OC DEVELOPMENT SERVICES REPORT

SUBJECT: Planning Application PA180015 for a Use Permit

PROPOSAL: The applicant is seeking a Use Permit for a 1,750 square foot addition and 200 square foot patio area addition to an existing restaurant, and for alternative parking regulations for the required off-street parking. Per Section III.D.10.3.a.3 of the Foothill/Trabuco Specific Plan additions to a restaurant use may be approved subject to Planning Commission approval and per Section 7-9-70.9(b)(3) of the County of Orange Zoning Code requests for deviations from the parking requirements shall be subject to approval of a Use Permit.

In Reference To: Revised Letter of Justification
Response to Plan Check Comments – Fourth Submittal
Resubmittal Documentation for PA180015
County Code Enforcement Case No. CE1606610
Trabuco Oaks Steakhouse

REVISED SITE PLAN

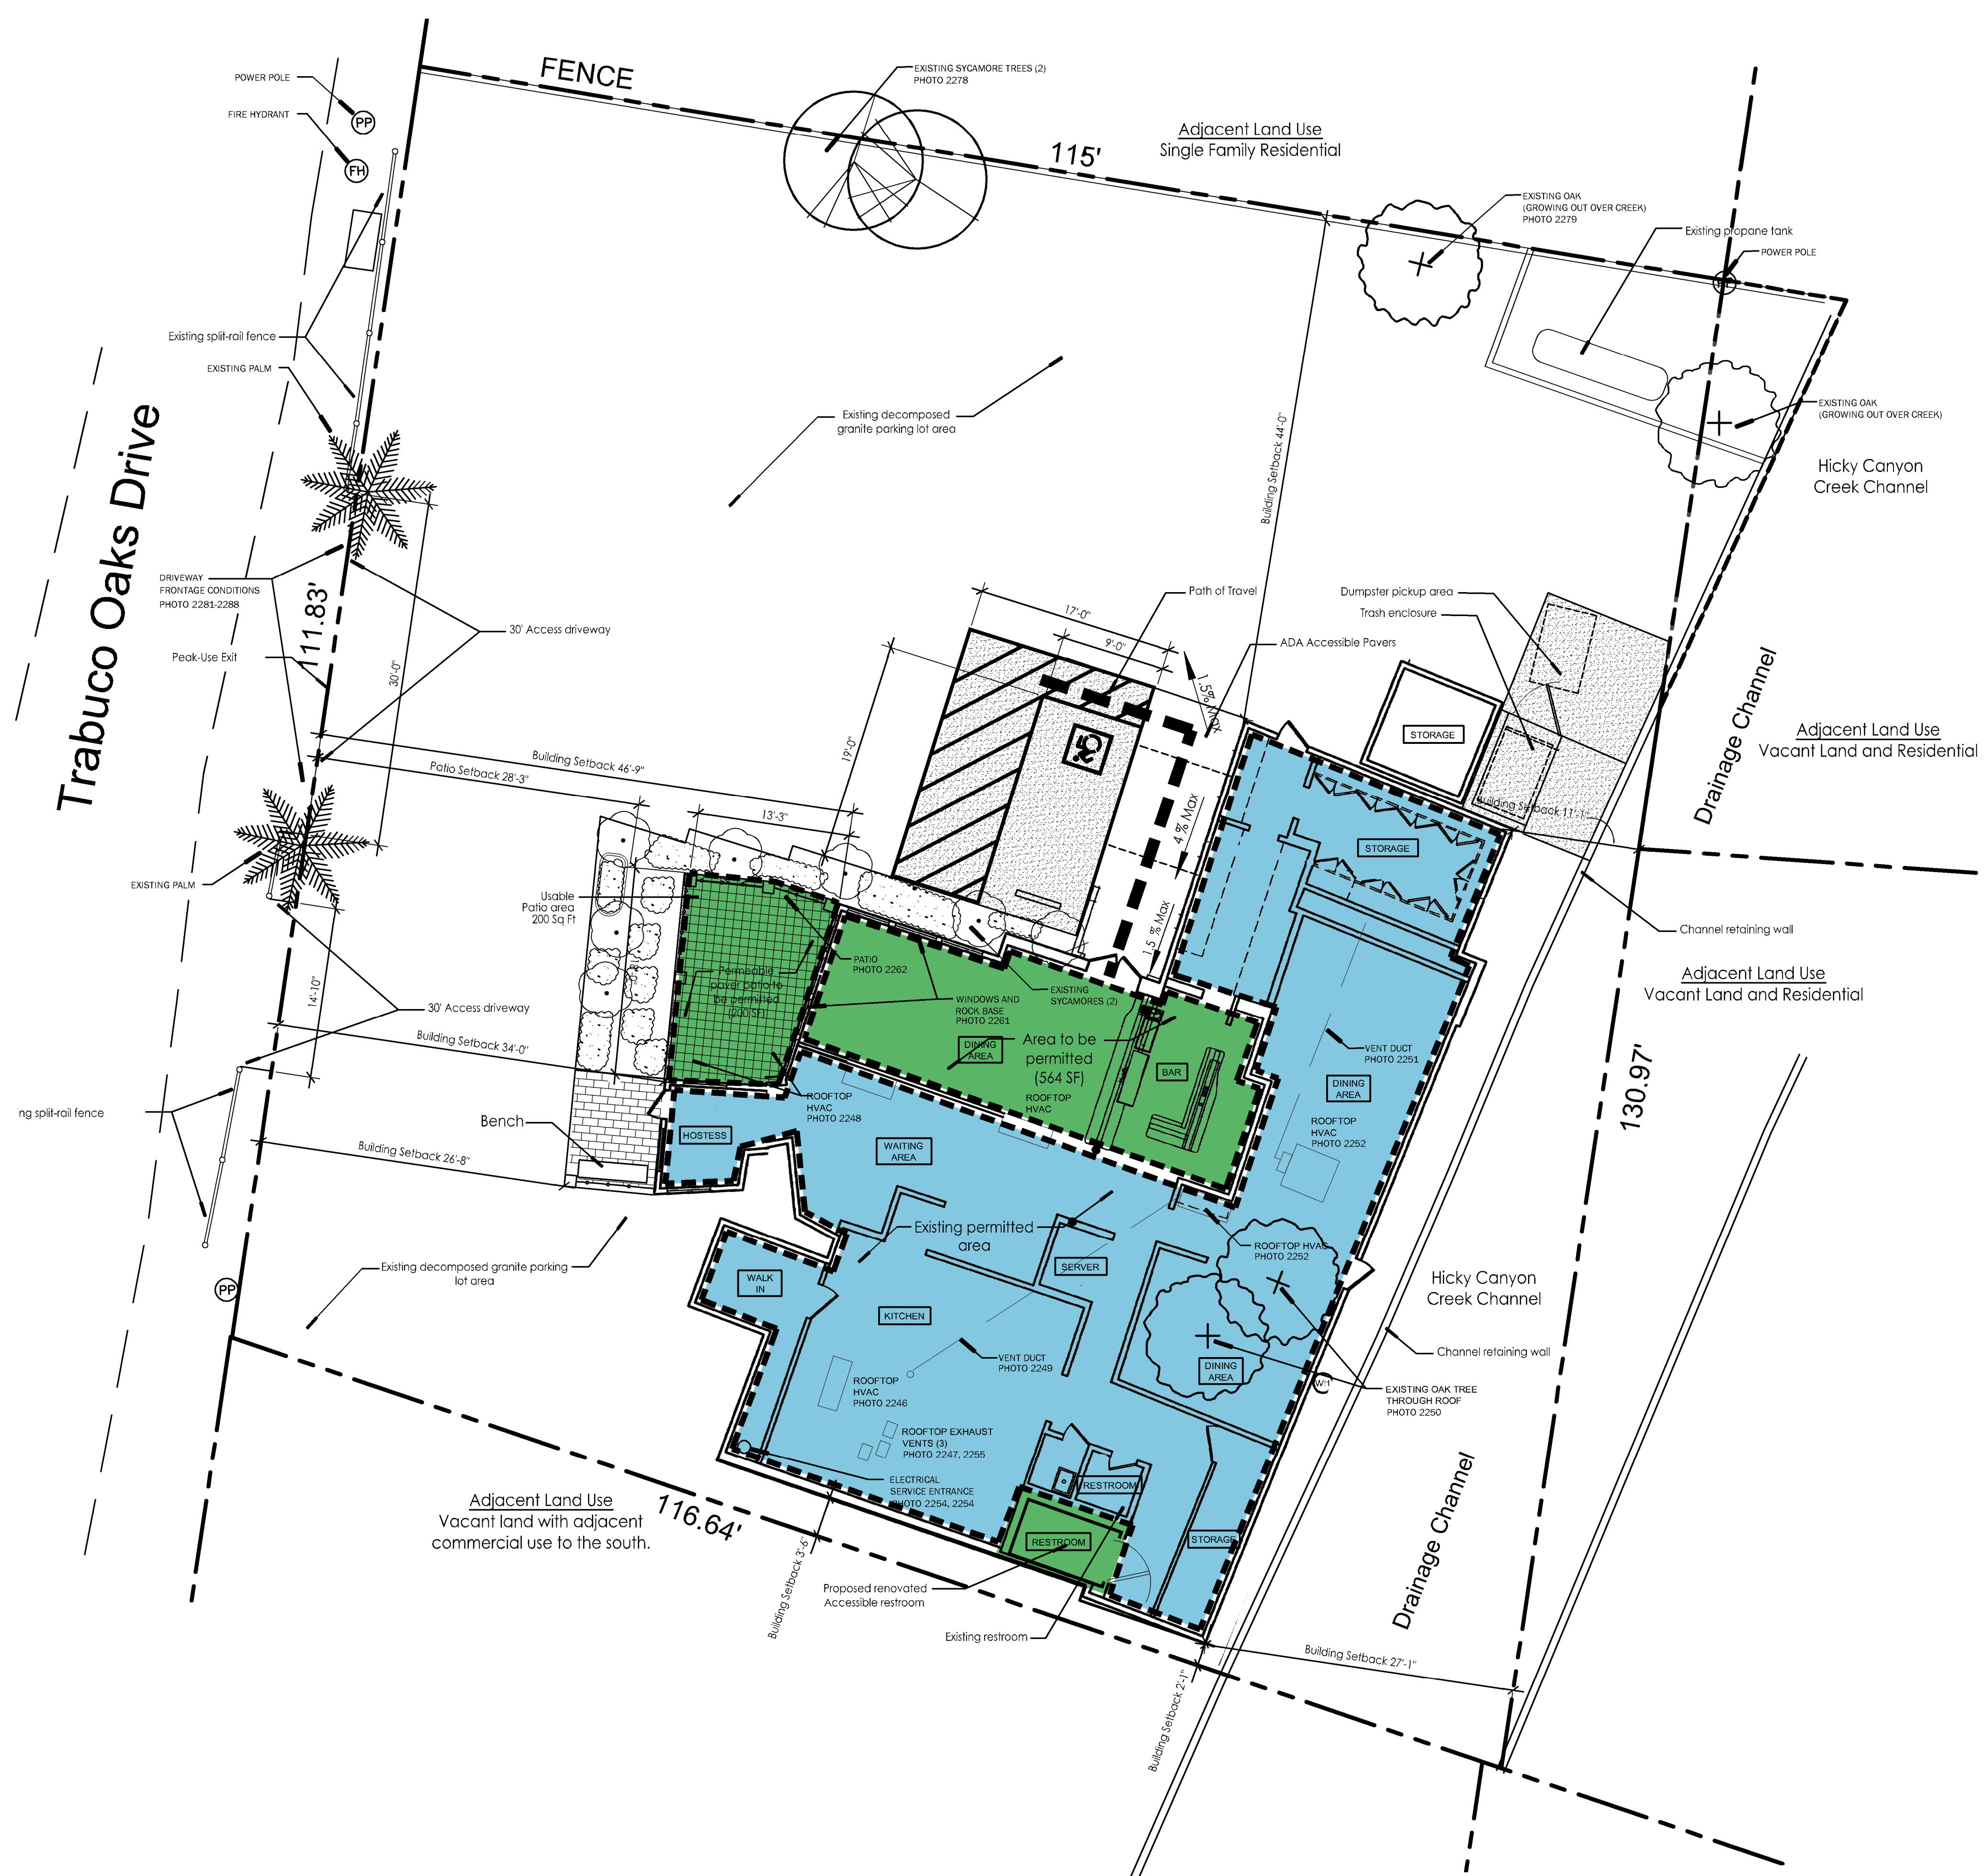
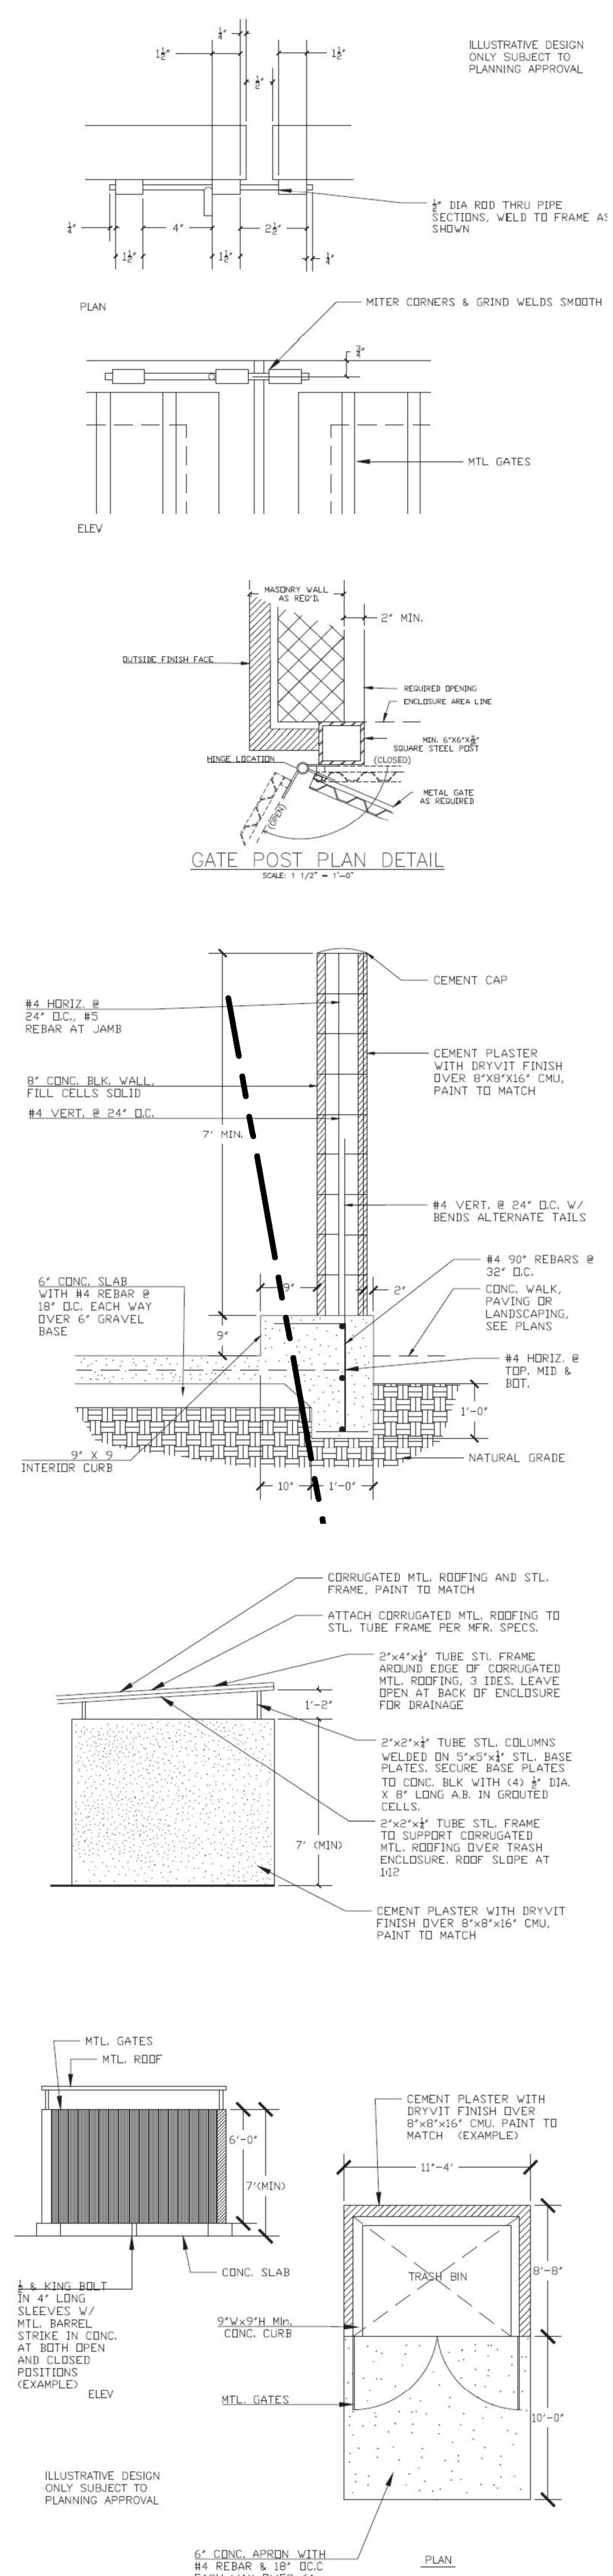
Comment 1.007: *Bar height must be accessible for a minimum of 5' in length.*

Comment 1.009: *Provide a full set of plans that include floor plans, elevation plans and sites plans.*

Comment 1.017: *Per Section 10.8(i) of the Foothill Trabuco Specific Plan all trash enclosures shall be enclosed by a wall not less than six (6) feet in height and must have a roof if located within forty (40) feet of any residential district. 1/14/20 – Provide elevation plans for the trash enclosure.*

Comment 1.025: *Include the dimensions for the existing patio in the site plan. 1/14/20 – This issue has not been addressed.*

Per the County staff redline comments on the previously submitted Site Plan, the revised Site Plan and details now show a trash enclosure and a detail of how the bar is being modified to comply with ADA compliance access requirements.

Response: There is a new Site Plan detail that shows how the bar is being modified to be handicapped/wheelchair accessible for a minimum of five feet (5') in length.

Response: A new Floor Plan/Site Plan is being submitted that respond to the County’s latest “Deemed Incomplete” letter dated September 9, 2021. The Revised Site Plan now shows a trash enclosure with an elevation, a smaller patio. It also includes details that demonstrates compliance with ADA bathroom and bar height requirements. The applicant did submit project elevations that adequately document the four building sides.

Response: The project now proposes a trash enclosure per Section 10.8(i) of the Foothill Trabuco Specific Plan. The Site Plan now includes a detail of the trash enclosure enclosed by a wall six (6) feet in height with a roof and an elevation.

Response: The attached Revised Site Plan includes a smaller patio with dimensions. Its size has been reduced to approximately 200 square feet.
